A6 MARR Clay Lane Junction Safety Report

Subject
A6 MARR EI29 – CPO Objection Clay Lane Alternative Layout

Our Reference
A6MARR-0-S-52-001-RE-001

Title	EI 029 CLAY LANE SIGNAL CONTROLLED JUNCTION OPTION
-------	--

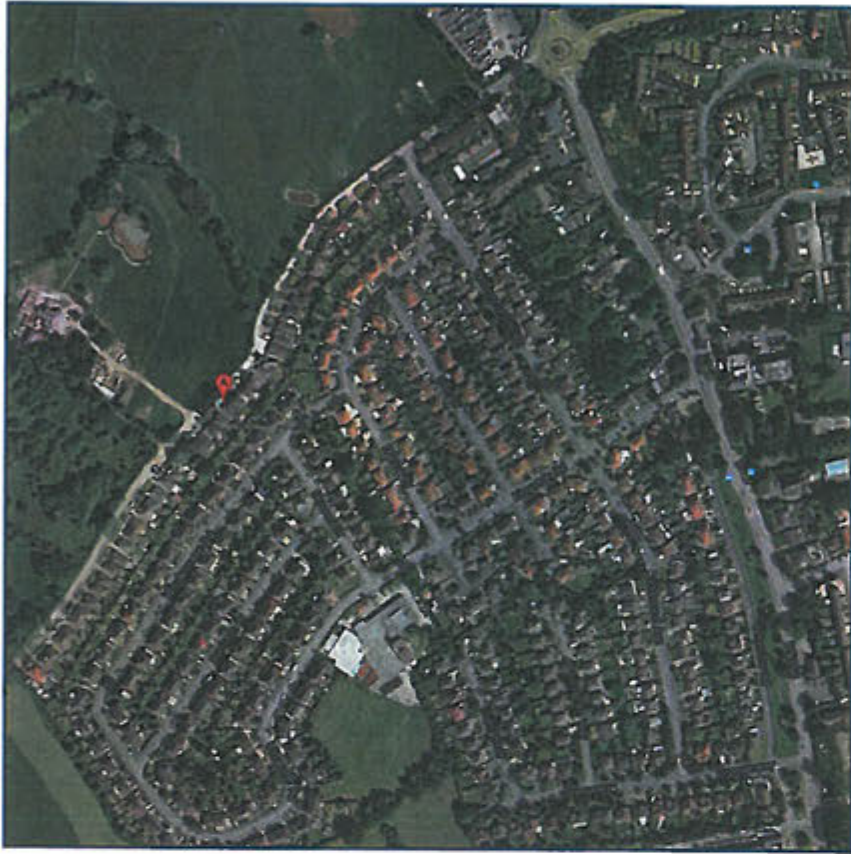
This statement follows on from the previous SEMMMS DF3 Stage 1 Safety Audit (ref. ES1/530 - 42120 Problem 20) which stated for a very similar layout *"incidents involving road users emerging from side road across entry slip and/or nose-to-tail type shunts. Sightlines and forward visibility for traffic exiting Clay Lane left onto the entry slip or across the westbound entry slip onto the eastbound slip for the roundabout maybe compromised due to the geometry of the roundabout. Additionally, road users entering the westbound entry slip for the Relief Road will be accelerating along the westbound entry slip road off the roundabout may not expect a junction on the slip road where traffic may intend to turn off the slip road onto Clay Lane and/or road users emerging from Clay Lane onto or across the slip road"*.

The Stage 1 RSA recommended *"ensure sightlines are maximised for both traffic egressing Clay Lane and traffic exiting the roundabout onto the slip road and/or reduce speeds of traffic entering the slip road"*.

Vehicles exiting the roundabout will be accelerating along the westbound on-slip ready to merge with the westbound mainline, they will not be expecting conflicting traffic in front of them. This traffic will comprise vehicles on the slip road slowing to turn left into Clay Lane - leading to shunts, as well as traffic exiting Clay Lane to access either the roundabout - leading to side-on collisions or turning left onto the slip road - again leading to shunts due to the probable speed differential.

This SK02 layout, which comprised a priority junction, was found to demonstrate similar problems to the above which would be difficult to remediate.
